NL Nuclear

July 6, 1979

Subject: NLI 10/24 Rail Cask
Certificate of Compliance No. 9023, Rev. 0

Attachment No. 1
Revision List - NLI 10/24 Rail Cask
Safety Analysis Report

ORIGINAL ISSUE VS. LATEST REVISION

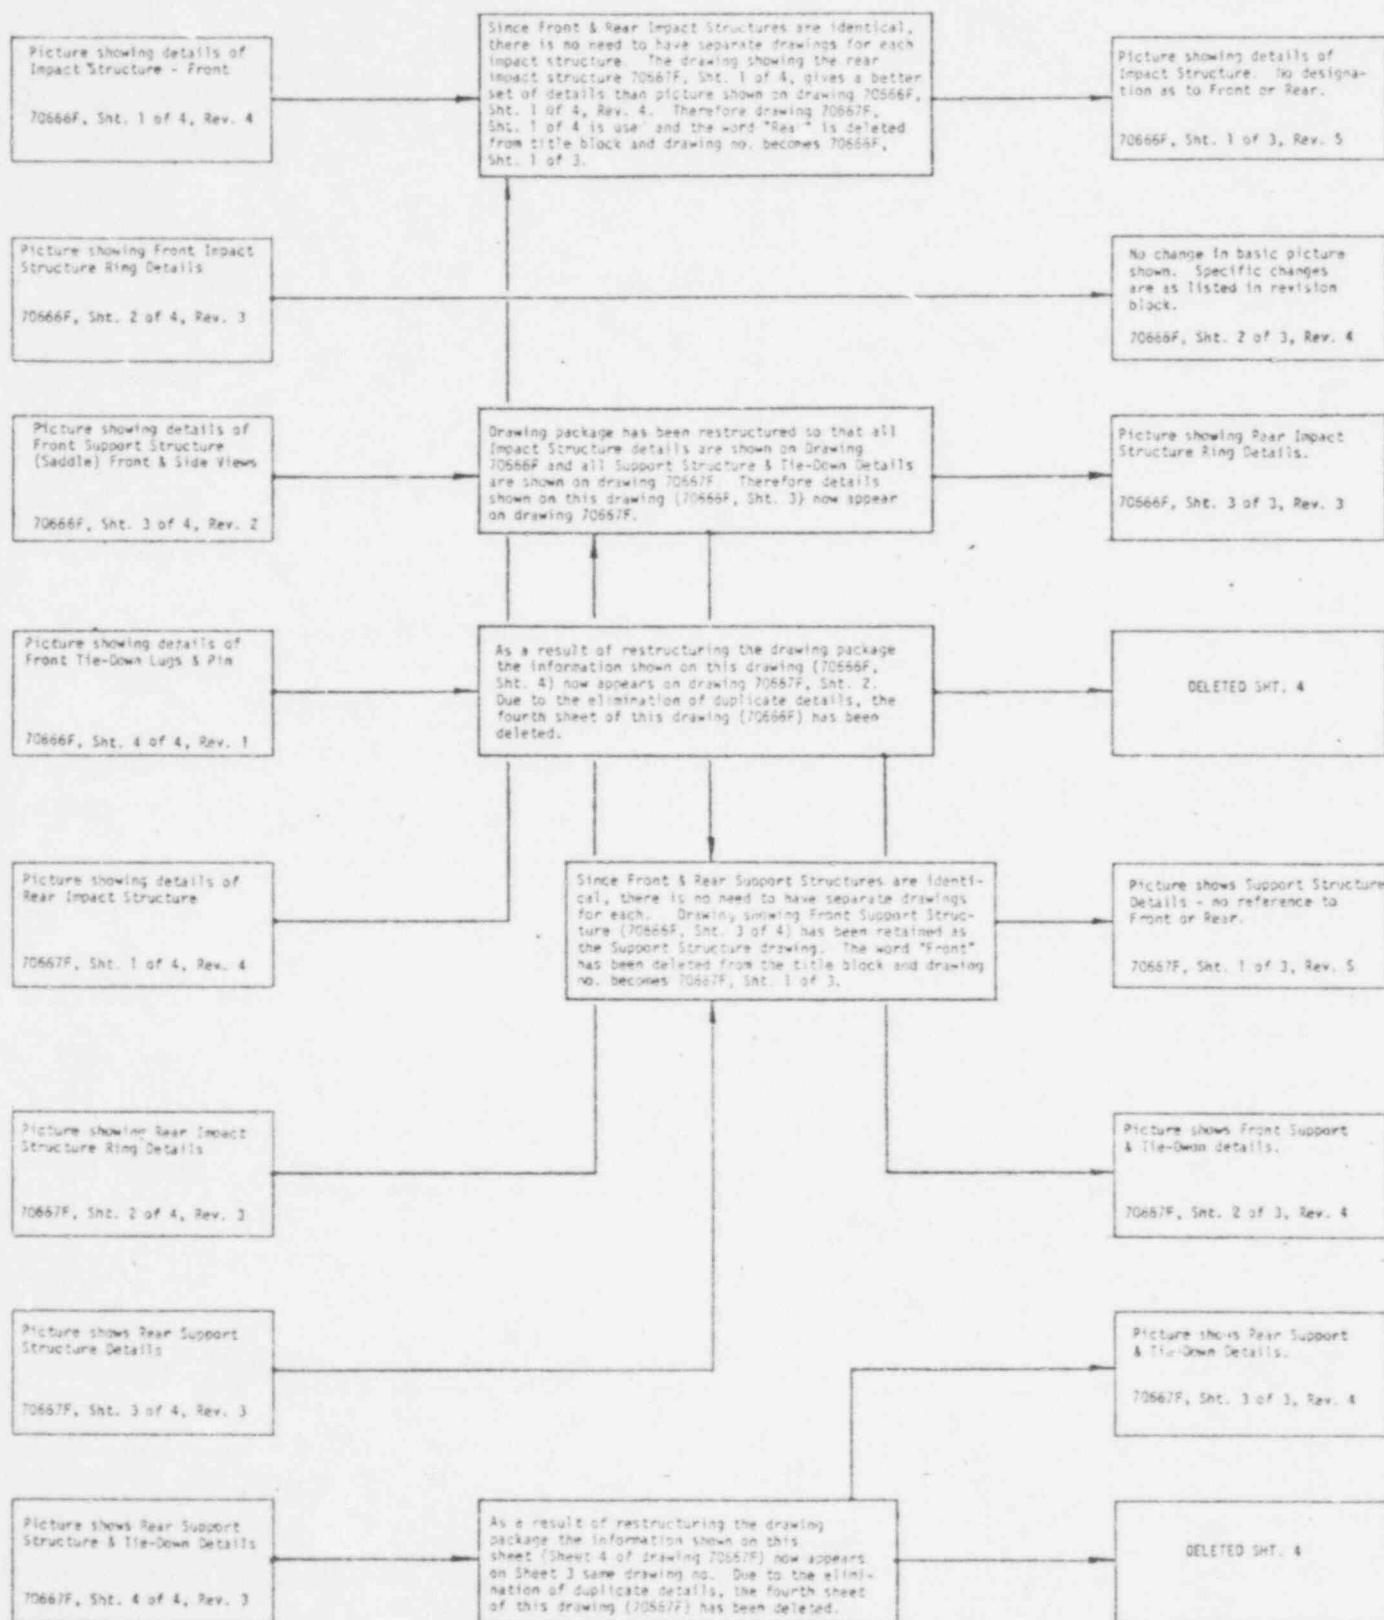
The drawing package was revised to eliminate duplication of information which reduces the number of drawings in the package. The drawing package was restructured so that all Impact Structure Details are shown on the series of drawings numbered 70666F and all Support Structure and Tie-Down Details are shown on the series of drawings numbered 70667F. On the following page is a flow chart type presentation which explains the new drawing package vs. the old drawing package. Two drawings showing Front & Rear Tie-Down Details required a correction to the Tie-Down Pin diameter. The drawings have been corrected and given the next revision level.

2.1.3 Inner Closure Lifting Lugs

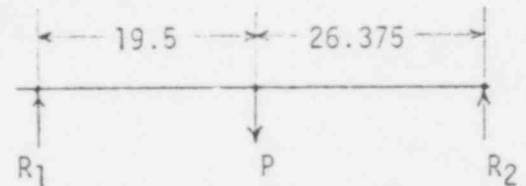
Page XI-2-5 has been revised to incorporate a statement specifying the method of lifting that will result in a direct vertical lift on each eye bolt.

2.2 Tie-Downs

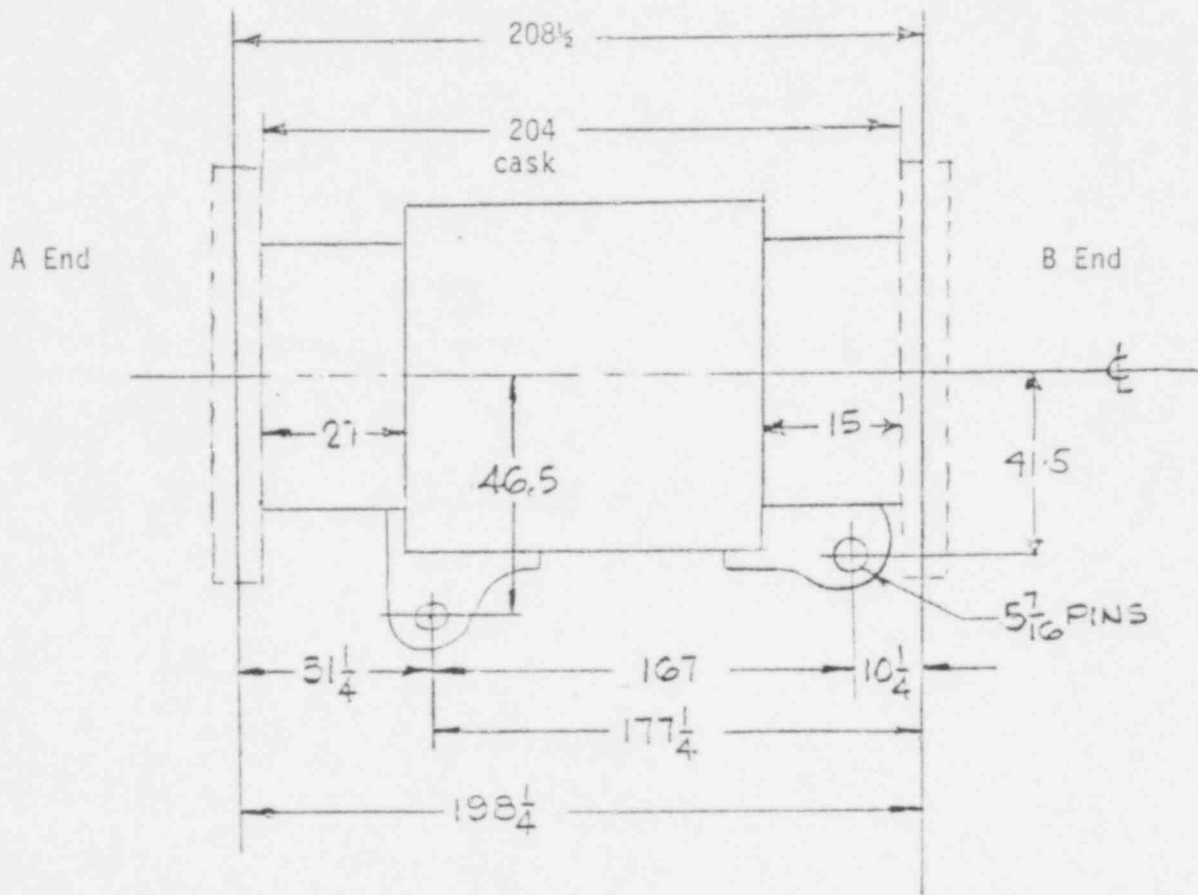
Dimensional changes to the figure shown on page 2-8 reflect the final detail drawing dimensions used to construct the casks. The specific dimensional changes are as follows:

- a) Distance between support points was 205 1/2 inches, now 208 1/2 inches.
- b) Distance from front or top end of casks tie-down lug to the center of the rear or bottom end of cask support point was 175.75, now 177 1/4 inches.
- c) Distance from rear or bottom end of cask tie-down lug to the center of the top or front end of cask support point was 197.75 inches, now 198 1/4 inches.
- d) Distance from the front or top end of cask tie-down lug to the center of the front or top end of the cask support point was 30 3/4 inches, now 31 1/4 inches.
- e) Distance from the rear or bottom end of cask tie-down lug to the center of the rear or bottom end of cask support point was 8 3/4 inches, now 10 1/4 inches.
- f) Tie-down pin diameter was reduced from 5.5 inches to 5 7/16 inches. This change was necessary to facilitate handling operations.

Dimensional changes (a) thru (e) resulted in a reduction of about 1,000 lbs. in the reaction loads at the support and tie-down points.

2.2.1.3 Front Cask Lug Analysis

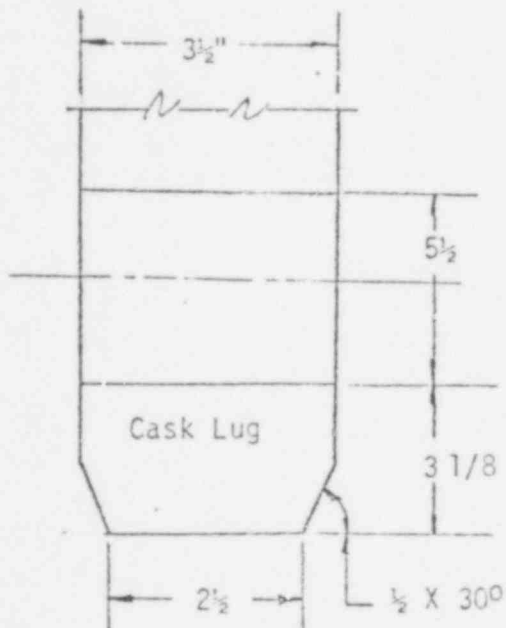
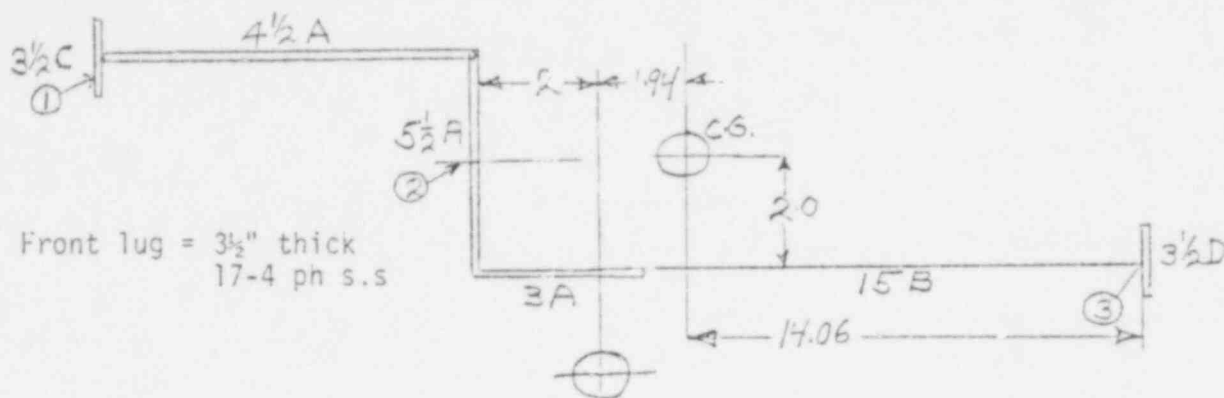
There is a slight change in the lug configuration. The change did not effect the hole size nor the amount of material around the hole. The change provided more material where the lug joins the cask which in turn resulted in additional length of welding. The stress analysis of the lug is the same as the previous edition except the loading is about 2100 lbs. less due to dimensional changes sited in (a) thru (e) above and in the calculation of tension stress the area has been corrected. The results of these changes has been to increase the margins of safety.

Two changes were made in the lug to cask weld analysis. The length of weld "A" increased from 2" to 4 1/2 inches and the assumption that the weld metal in the throat of the weld has a strength at least 90% of that of the base metal (17 - 4 PH) has been deleted in favor of a more conservative approach. It is now assumed that the weld metal is no stronger than the weaker of the two base materials, i.e., 304 stainless steel. The analysis is the same as presented in the previous edition except the margins of safety are less than previously reported due to the change in assumptions which reduced the weld strength values.

2.2.2.1 Rear Cask Lugs - B - End

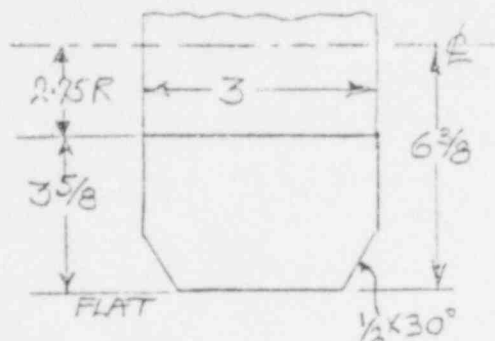
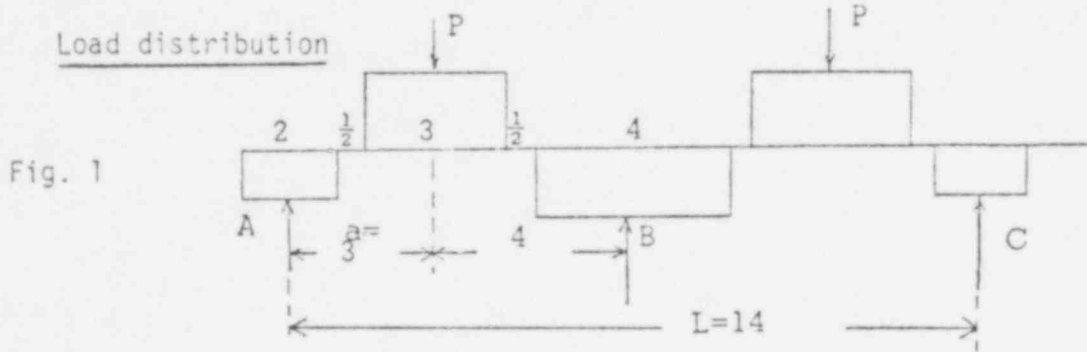
Only minor corrections were made to the sketch of the lug shown in the SAR. The 7 inch R. is 7 1/8 inches and the 3.5 inch dimension is 3 5/8 inches. The thickness and all other dimensions of the lug remained the same as originally shown. These changes had little effect on the lug analysis. Margins of safety remained essentially the same as originally reported due primarily to the correction of area calculations.

The lug to cask weld analysis is essentially the same as previously presented. As in the case of the front cask lug the assumption on weld metal strength has been revised which has resulted in a reduction in the margins of safety.

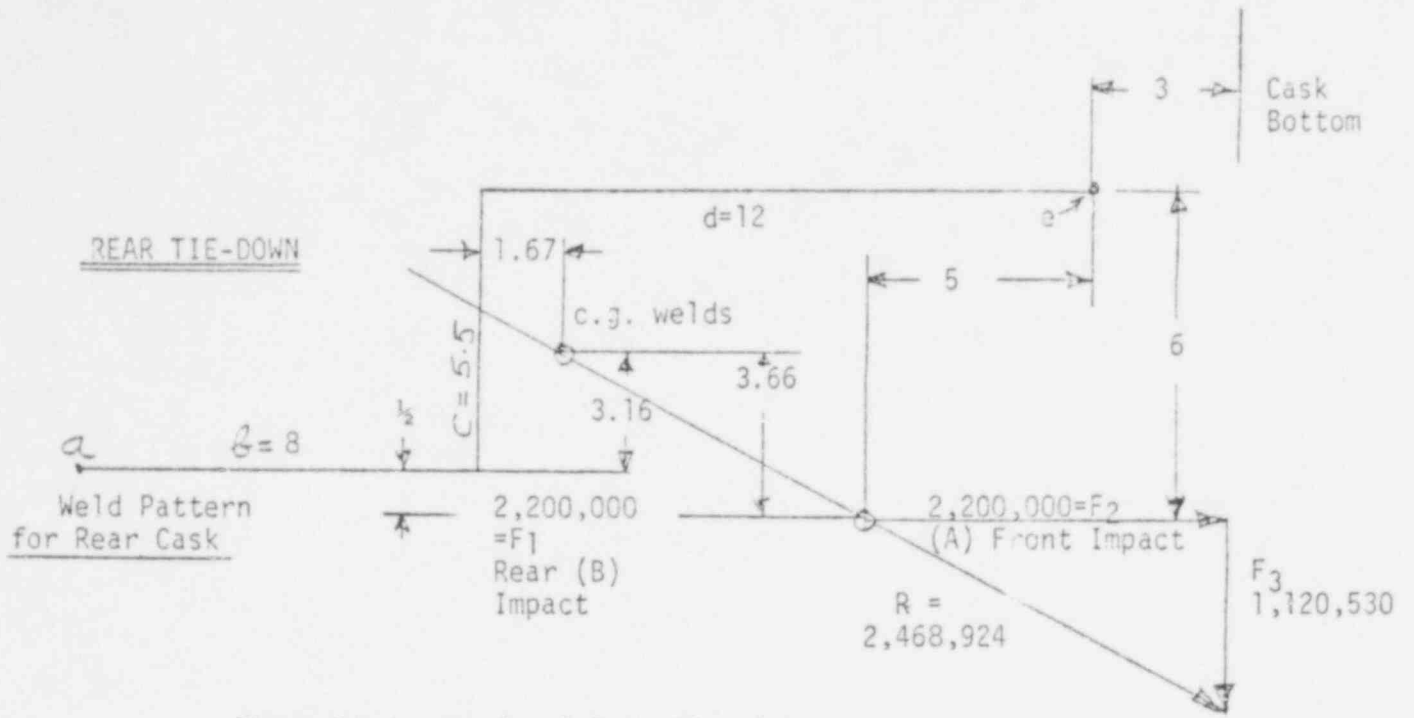
There is no change in the length of welds or the weld pattern. The following changes were made in weld size:

| <u>Weld</u> | <u>Size</u> |
| "a" | was 1" fillet, now 1 1/2" fillet |
| "b", "c", "d" | was 1 3/4" fillet + 1/2" penetration now 1 1/2" fillets + 1/2" penetration |
| "e" | was 1" "J" weld now 1 1/2" fillet |

The above resulted in a slight reduction in total weld area (was 175.992 in.², now 166.86 in.²). The reduction in weld area combined with the reduction in allowable weld strength has resulted in a general reduction in the margins of safety. The design, however, still falls within the allowable stress criteria (.9 times yield).

2.2.3.1

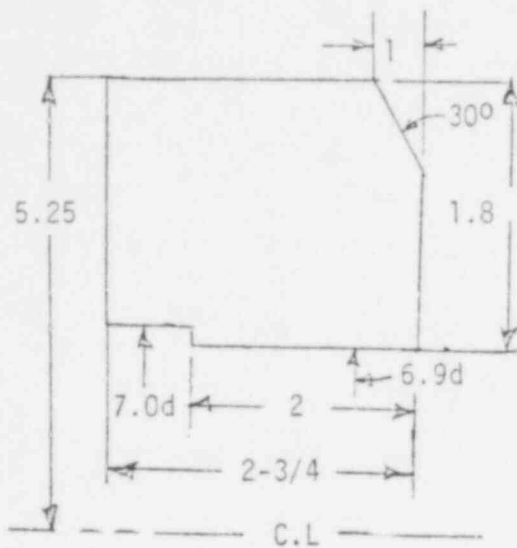
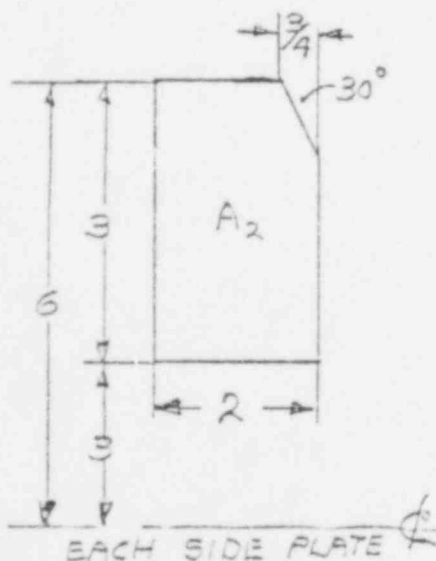
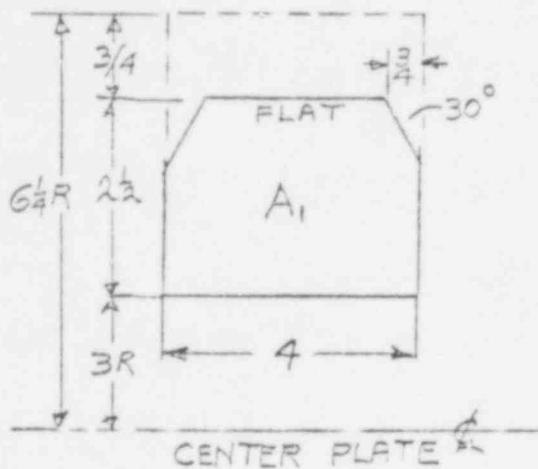
The lug analysis presented in this revision has corrected some dimensional errors which existed in the previous edition. Specifically the 1.8 dimension was 2 inches and the 2 3/4" dimension was 3 inches.

Another difference in this analysis is that the allowable design strengths are taken as 100% of the ultimate tensile stress, since the prime concern is the behavior of the rail car lugs during an accident condition.

The only other change in the front tie-down lug design is a reduction in the size of Weld 2 from 3/4 inch fillet to 9/16 inch fillet. The original calculation used the ultimate tensile strength of the lug material (115,000 psi) which resulted in a break away force of 3.25 g's. The revised calculation uses the ultimate tensile strength of the weld metal (95,000 psi) which results in a break away force of 3.55 g's.

Weld 3 Spacer plates to railcar center sill (2)

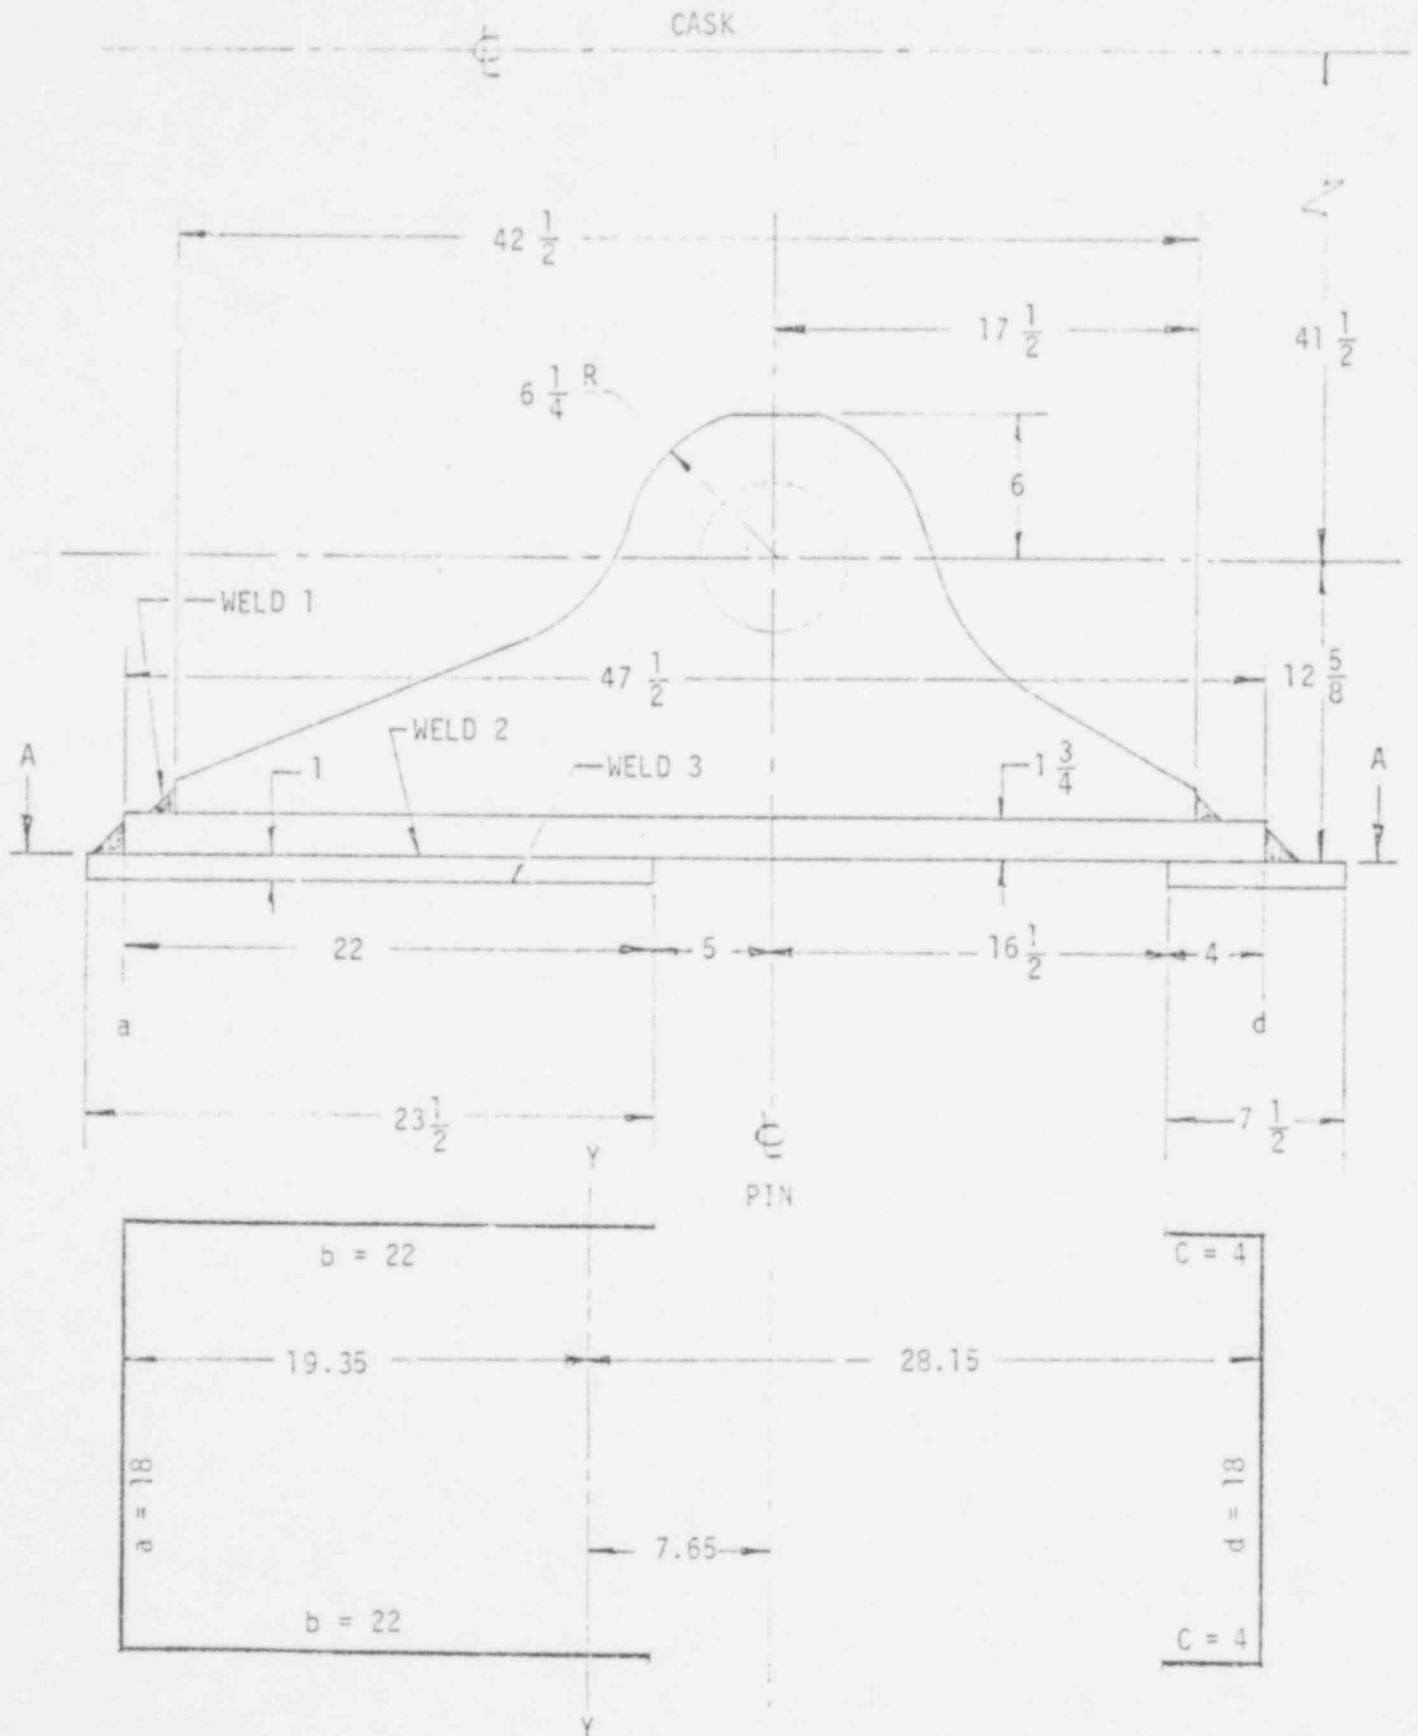
The following changes were made in the attachment welds identified as welds 1, 2 and 3.

Welding: The previous calculations assumed that the strength of the weld joint was equal to that of the base metal, 100,000 psi for T-1 material. The revised calculations used the weld strength of the filler metals as listed on page XI-2-22g. This resulted in a reduction in allowable stress.

Weld #1: The previous weld size was 1 1/2 inch "J" groove with a 1 inch fillet. The revised weld size is 1 1/8 inch "J" groove with a 1 inch fillet. The length of the weld has been reduced from 44 inches to 42 1/2 inches. These dimensional changes still provide a weld which is stronger than sacrificial weld no. 2.

Weld #2: Bottom plate of weldment was 1 1/2 inches thick, now 1 3/4 inches thick. Fillet weld size has been increased from 1 inch to 1 3/8 inches. Length of the weld has been reduced from 95 inches to 88 inches. The net effect however was an increase in square inches of weld from 67.165 to 85.55. These changes did not effect the function of the weld as far as being the plane of separation in a severe accident.

Weld #3: There is a slight reduction in the number of lineal inches of weld but an increased in weld size. The weld was a 1 inch fillet. The weld joint now is a 3/4 inch J groove plus a 1 inch fillet. The revised weld joint geometry produces a weld which is stronger than Weld #2 which is the desired condition.
